## PUBLIC PARTICIPATION REPORT

# GOURIKWA-NARINA 400KV POWER LINE AND SUBSTATIONS UPGRADE (SCOPING TO EIA PHASES)

(DEA Reference: 14/12/16/3/3/2/921)

**PROJECT PHASE: EIA (PHASE 1 & 2)**

Figure 1: Map indicating the farm boundaries and pivots.

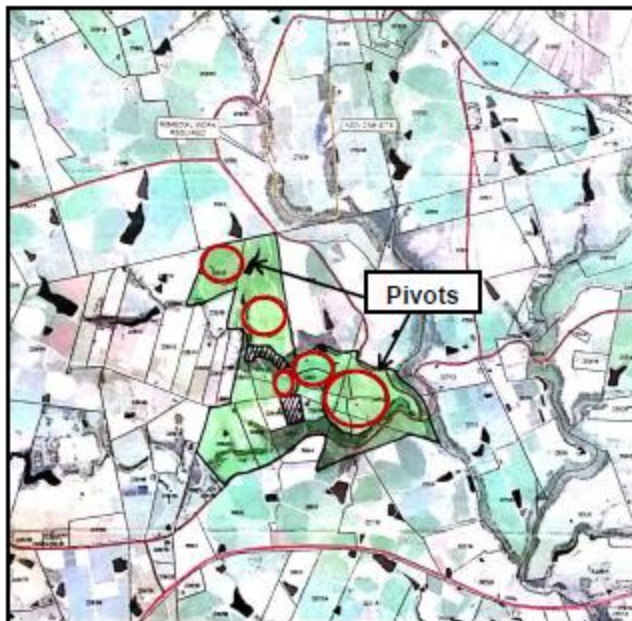
Figure 1 illustrates the boundaries of the Jonck family farm. The red circles indicate the pivot watering systems. These pivots are used for the irrigation of the pastures and are essential for the functioning of the farm. The five pivots are spread out over the whole farm, therefore preventing any possible alley way for the proposed power line.

The statements mentioned above are the reason why the Jonck family opposes against the proposed power line and an alternative route should be considered.
